LIGHTING CONSTRUCTION

PROJECT NAME: RUTLAND CITY	PLOT DATE: 5/20/2014
PROJECT NUMBER: STP 019-3(57)	DRAWN BY: PZA
FILE NAME: ...drawing\rut.light.dgn	CHECKED BY: GAE
PROJECT LEADER: GAE	SHEET 357 OF 392
DESIGNED BY: TFD	
LIGHTING & ELECTRICAL PLAN LE-02

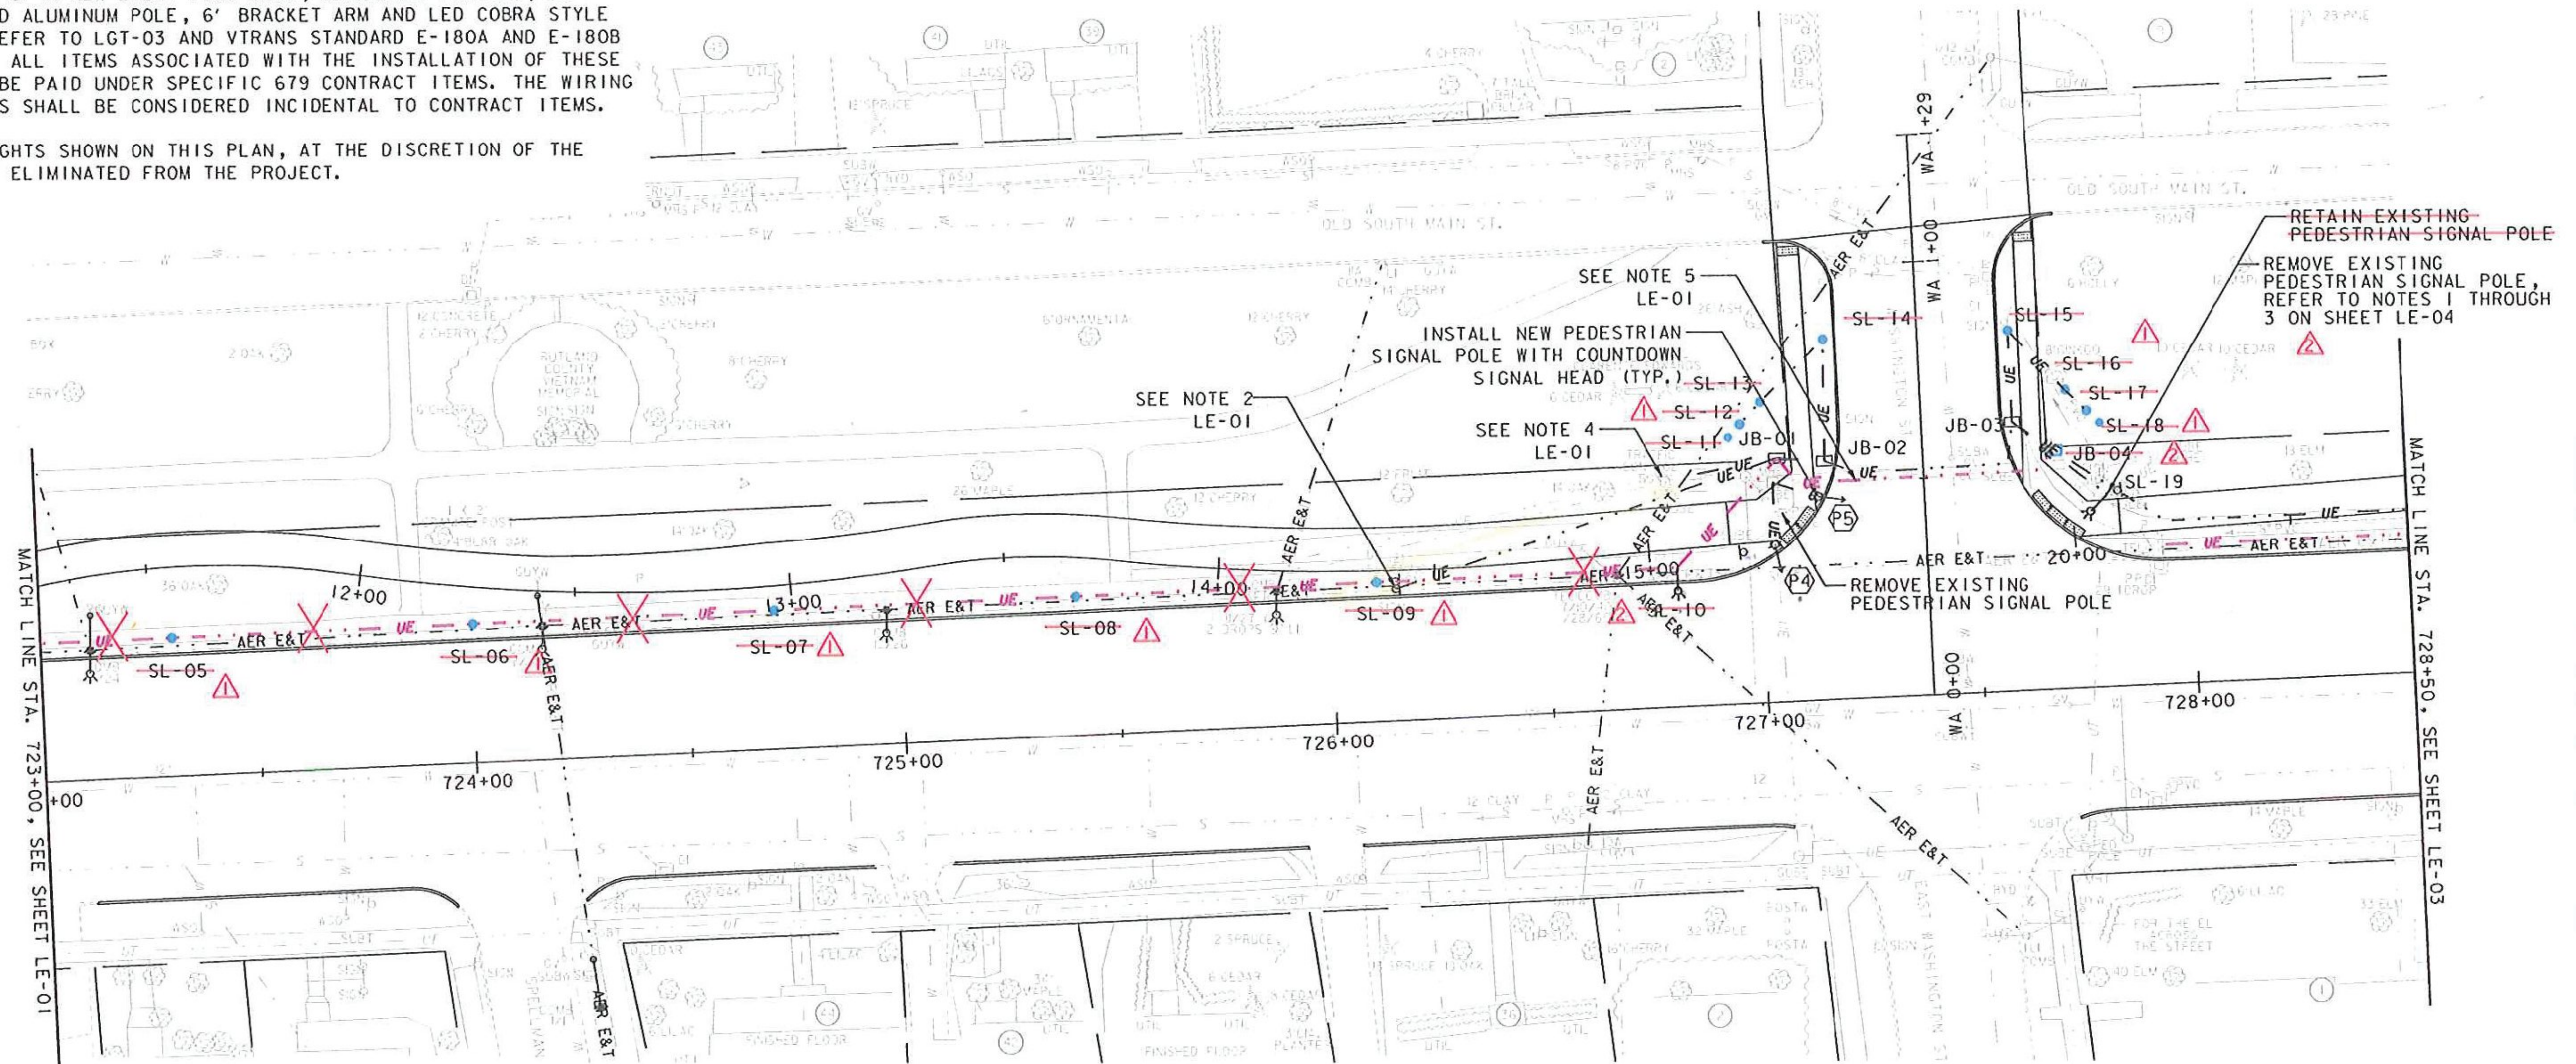
REVISION	BY	DATE
△ CONDUIT AND LIGHTING REMOVED FROM CONTRACT	TFD	11/05/13
△ SL-10 - REMOVED SL-19 - MOVED	TFD	05/20/14
